End Insulators for DCA310

TS-SSC 91-107
S. Delchamps
June 5, 1991

Figure 2a.

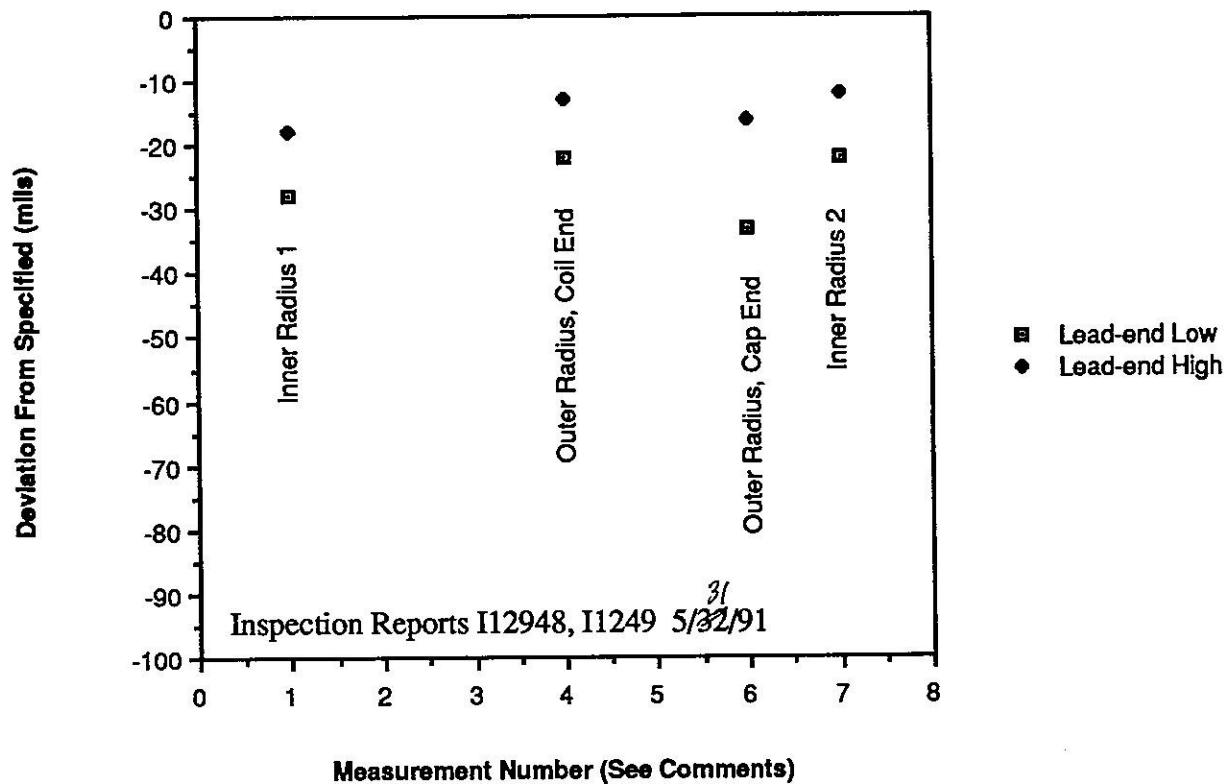
Inner and Outer Radii: Figures 2a and 2b show the deviations in mils from the specified values of all radius measurements. These measurements are seen to be consistent with a fairly uniform "bowing" of the part, which has been seen before in G10-CR end insulators. This bowing is expected, since the four insulator quadrants are cut from a cylinder with the correct dimensions¹, thereby allowing built-in stresses to relax. The uniformity of the radius decrease from inner to outer radii implies that the parts have the correct thickness.

DISPOSITION: Since the bowing of the parts will probably disappear upon installation, I recommend going ahead with installation of these parts. We might consider cutting radial grooves in the parts to allow them to conform more easily. This has been recommended on several occasions by John Carson, but I have never tried it.

Figure 1.

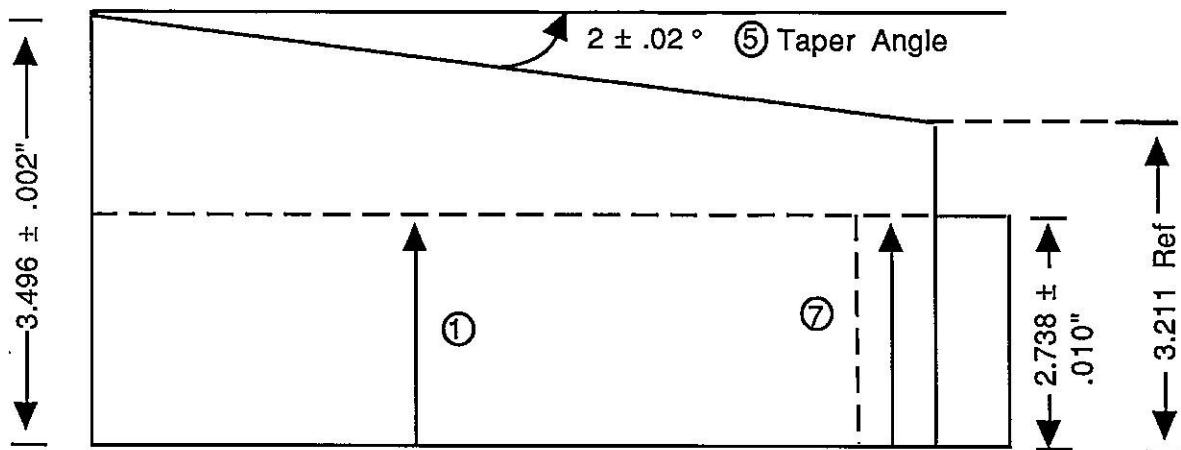
Inspection reports I12940, 12946, 12948, and 12949 give Cordax measurement results for G10-CR lead and non-lead end insulators to be used in magnet DCA310. Figure 1 shows schematically which measurements are found to be out of tolerance. These measurements and their minimum and maximum deviations from specified values are given in Table 1. The first column of the table gives the specified tolerance range for each of these measurements.

x and y Plane Offsets: These offsets from the datum coordinate x and y axes are meant to provide 32 mils of clearance at each quadrant boundary. The negative values for the offsets reported by the Cordax measurements are due to the bowing inward of the parts, which unfortunately renders these measurements virtually meaningless.

Taper Angle: The range of deviations from desired taper angle implies a range in the difference between reference dimension 3.211 inches and the dimension 3.496 inches (see Figure 1) of + 9, -15 mils. It is not immediately clear to me what should happen to this taper angle when the insulators bow in.

I would like to understand the taper angle issue better. The specified range in taper angle ($\pm .02$ degrees) implies a ± 4.9 mil range in the 3.211" reference dimension if the ± 2 mil tolerance in the 3.496" dimension is taken into account. I don't know what the taper angle tolerance should be.
